Planning Commission Staff Report

Project type: Amended Architectural Elevations
Meeting Date: December 9, 2019
From: Chris Dietz, Planner 
Location: 17392 Chesterfield Airport Road
Description: **Chesterfield Commons West, Lot 1 (Walnut Grill):** Amended Architectural Elevations for a restaurant building on a 0.84-acre tract of land, zoned "PC" Planned Commercial District located on THF Boulevard, northeast of its intersection with Public Works Drive.

Figure 2: North Elevation

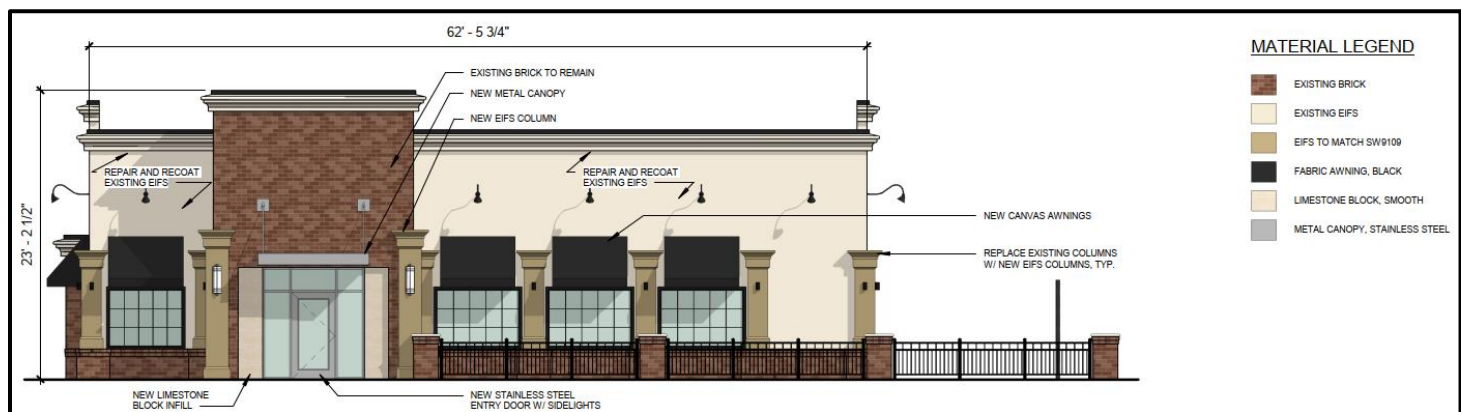
The existing brick and EIFS material on the building are to remain unchanged as they offer consistency to the other buildings within this development. The existing metal awnings over the windows are to be replaced with fabric material, while the metal canopy over the patio is to be removed entirely. EIFS columns are proposed to replace the existing wood columns and are intended to slightly contrast with the existing color found on the building.

Figure 4: Rendering

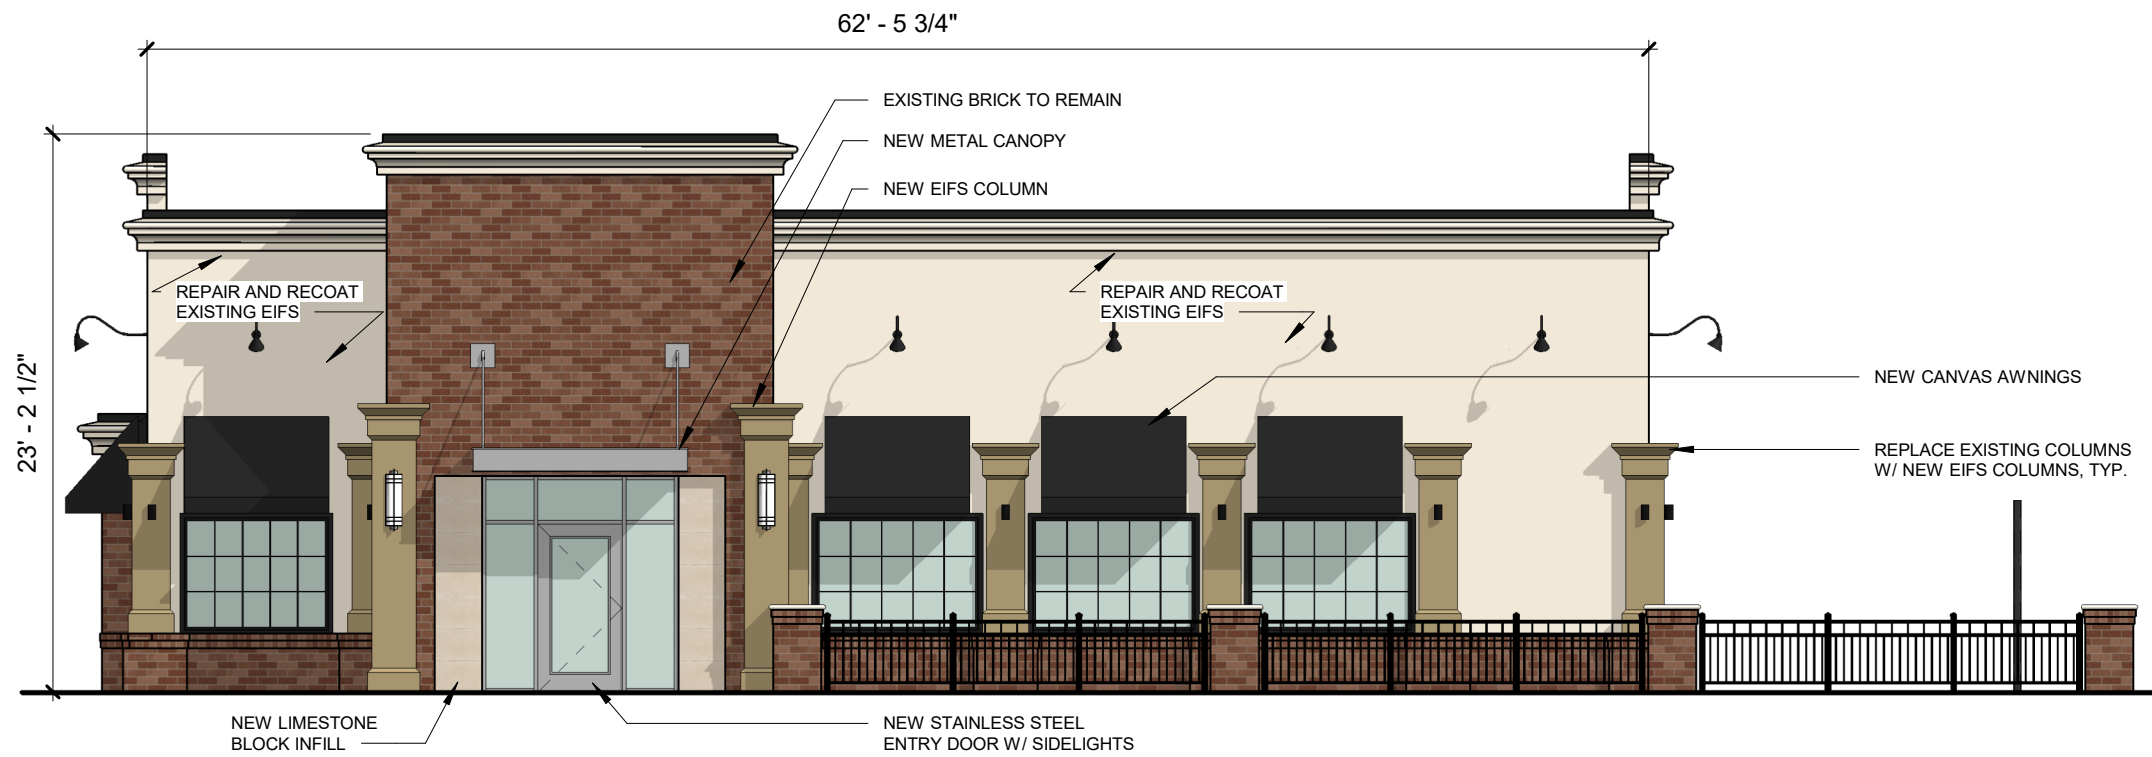
An accent lighting fixture, located on either side of the main door are neither flat-lensed nor fully shielded and must be reviewed by Planning Commission for fixture design exemption. The UDC allows Planning Commission to approve decorative light fixtures as an alternative to shielded fixtures when it can be proven that there will be no off-site glare light trespass in excess of five-tenths (0.5) footcandles and the proposed fixtures will improve the appearance of the site. These fixtures were reviewed by the Architectural Review Board, who did not have any concern regarding their design. All other lighting fixtures comply with lighting standards set forth in the Unified Development Code.
